Ground Floor Flat
5 Hillfield Road
London NW6 1QD

Re: Planning Reference 2021/2596/P

**Description: Site R/0 1 Hillfield Road NW6 – OBJECTION TO APP 2021/2596/P
OBJECTION BY 5 HILLFIELD ROAD – OVERSHADOWING ADDENDUM**

**Site Address: Land between Gondar House and South Mansions, Gondar
Gardens and to the rear of Hillfield Road, West Hampstead, London NW6 1QD.**

June 21st
20.00

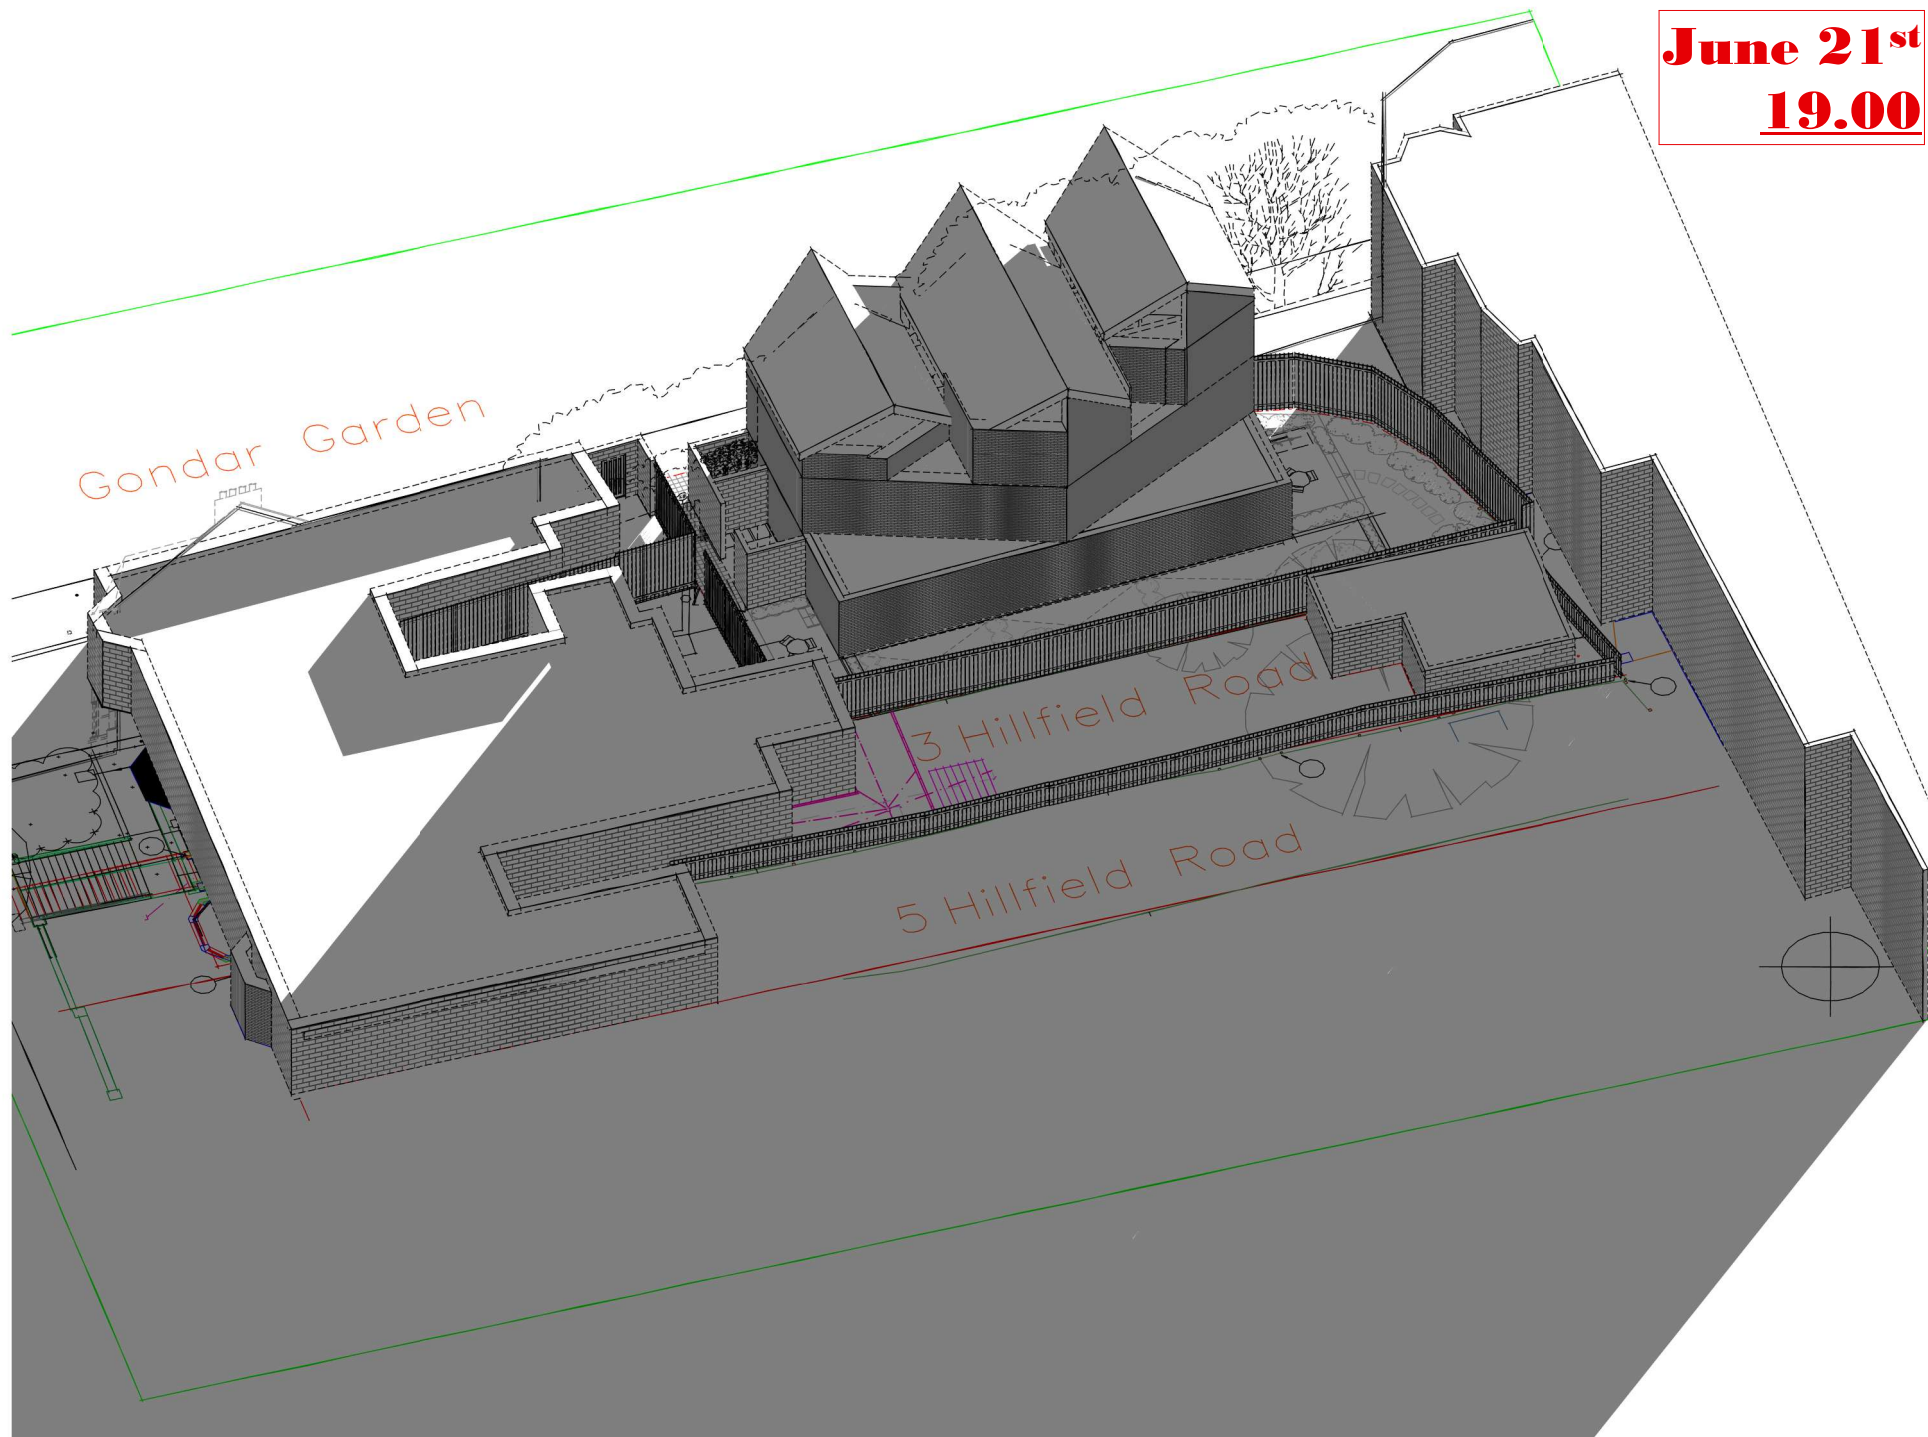
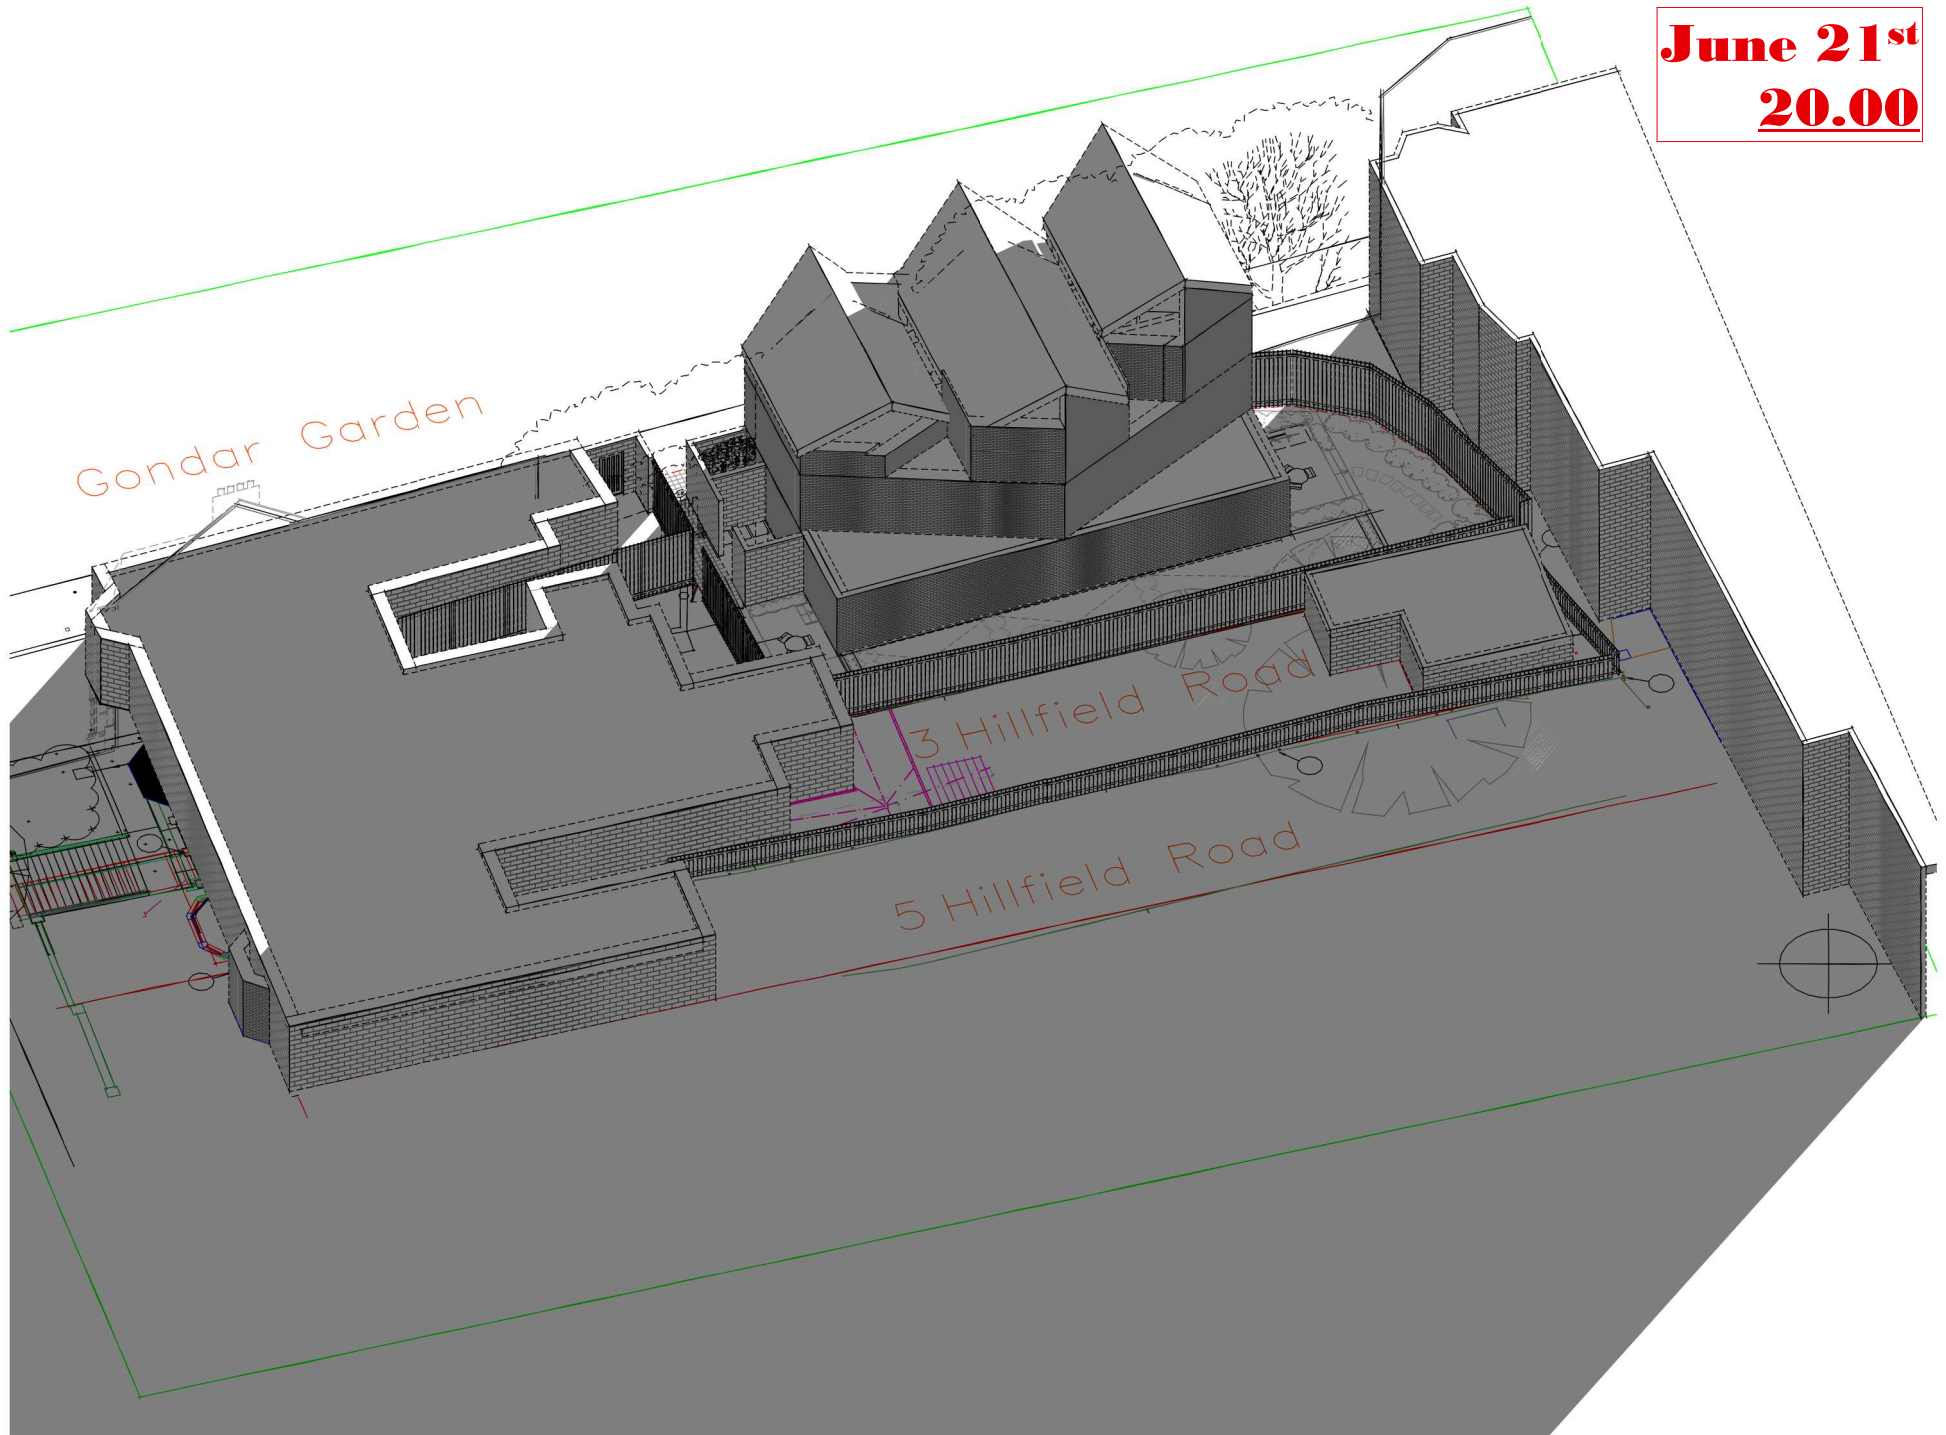
Our own modelling has Gondar House only as ground floor as such the modelling does not show full height of the building and hence not the correct overshadowing on 1 Hillfield Road patio area which will be much worse than the current modelling. The modelling was done to show the extent of overshadowing on 3,5 & 7 Hillfield Road gardens. Also, our model below shows the overshadowing at 21 March. The model shows that the sun is blocked from 14:00 o'clock on 3 Hillfield Road and from 15:00 it is blocking 5 Hillfield Road, the overshadowing continues till sunset at 18:15. We went further to do analysis in June and the overshadowing continues till sunset at 21:00.
